Hi Noon Ski Club | 12 Banjo Drive, Thredbo | Proposed Concrete Access Ramp

Road Safety Assessment

Prepared for
Hi Noon Ski Club Ltd

4 February 2025

Figure 1-1 Subject Site Area

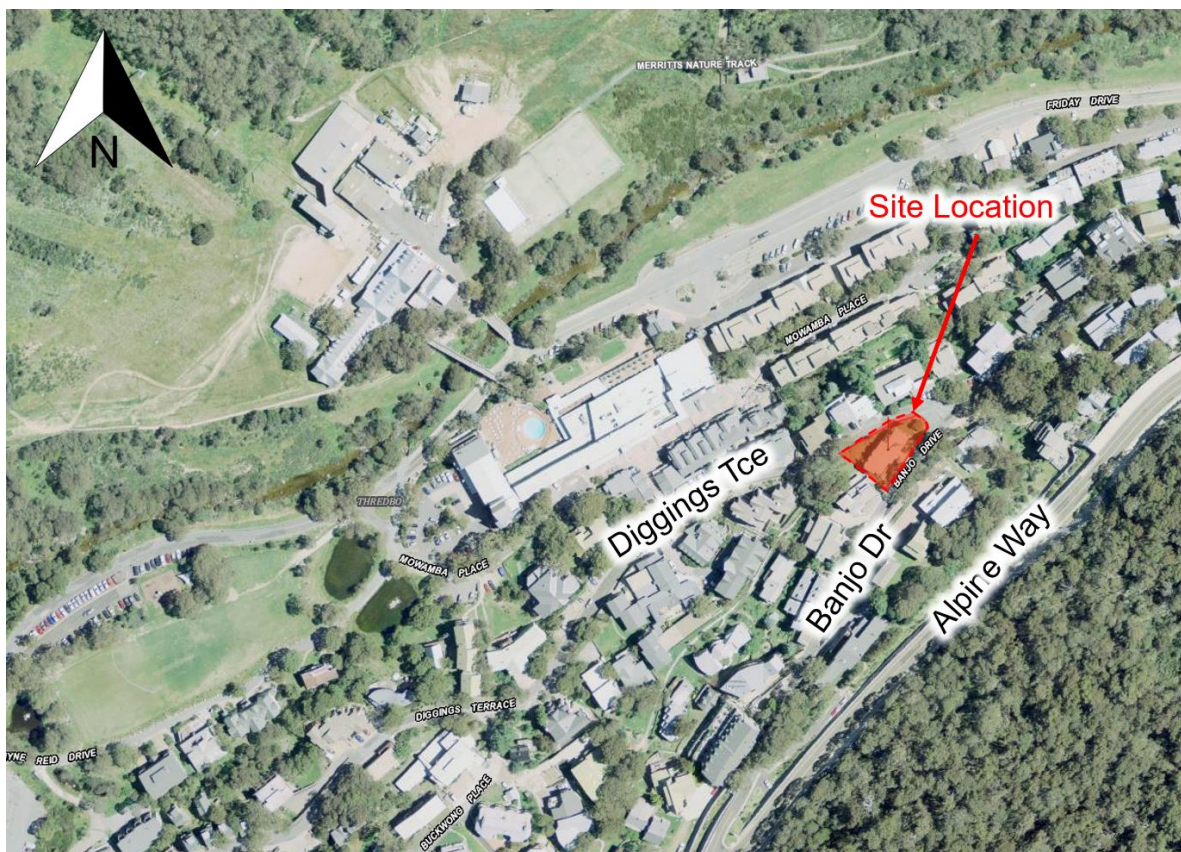
The location of the assessment and the proposed ramp and footpath are shown in Figure 1-1.

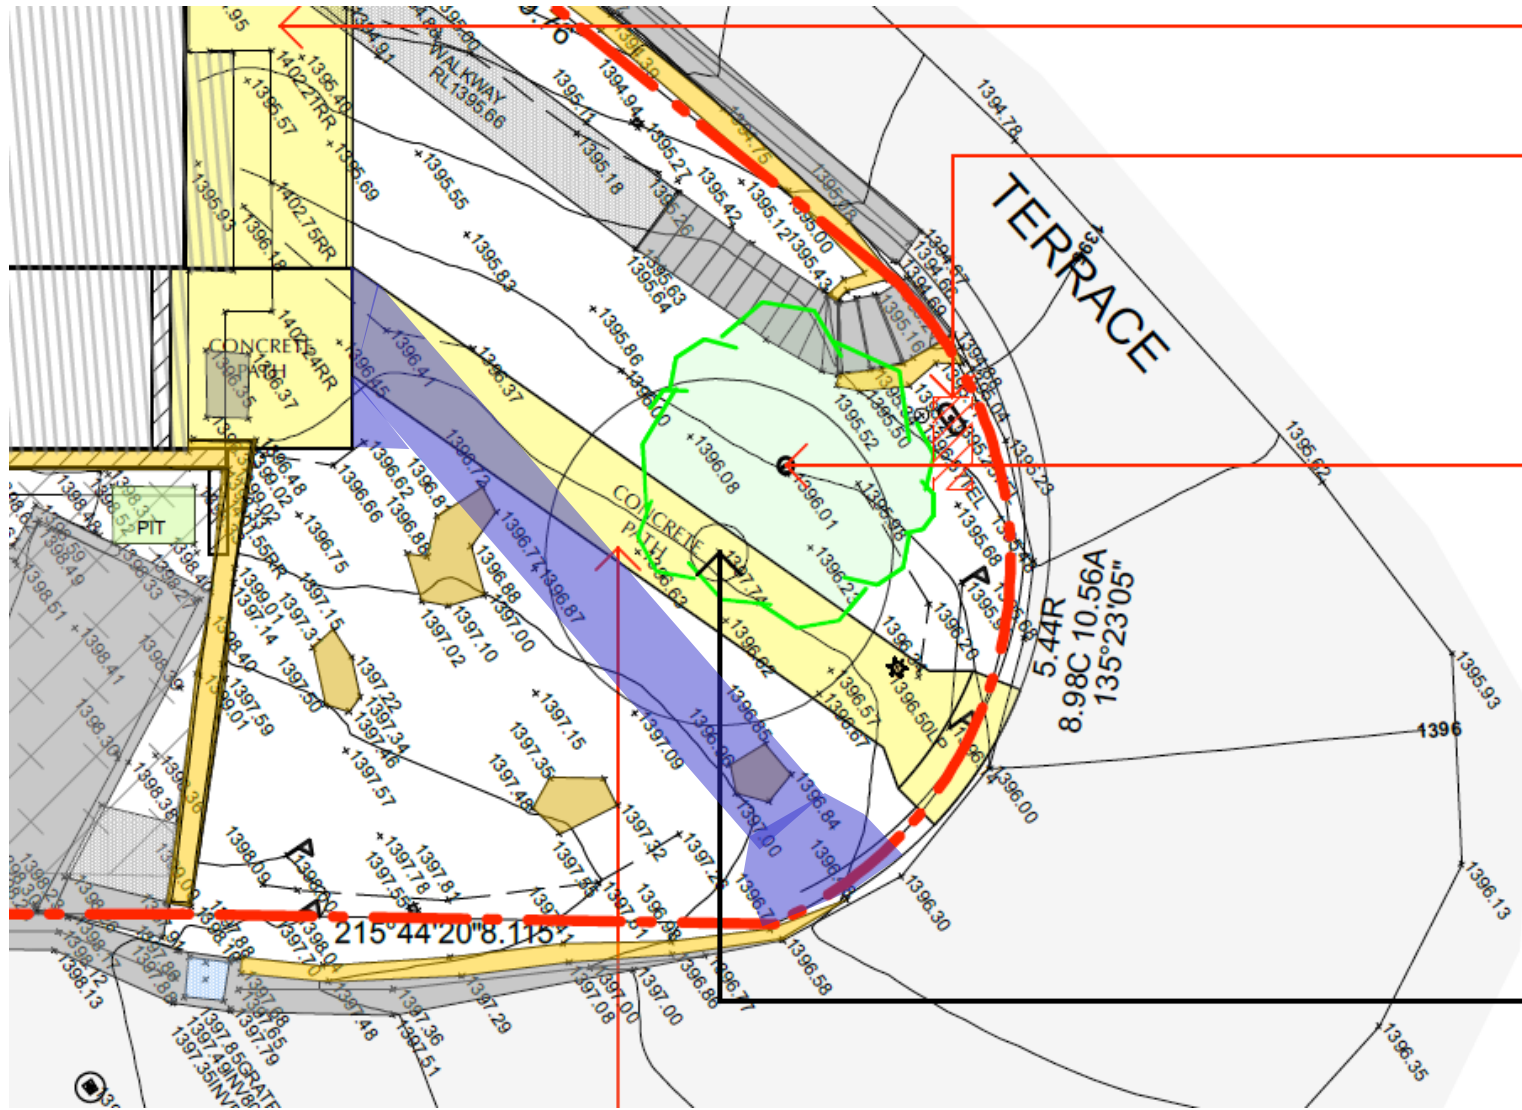
Please note that Practical Engineering Design Shows the tree outside of the footpath as it is the intension of the design and site measurements to protect the tree while building a pedestrian access footpath at Hi Noon Thredbo

The club has provided a sketch attached – where it indicates that the location of the tree is to remain.

This is to assess that there are no changes to the engineering design drawings listed above – regarding maximum slopes, etc - for wheel chair access footpath, while the tree is being retained.

NOTE: TREE SHOWN IN PATH LINE DOES NOT EXIST.
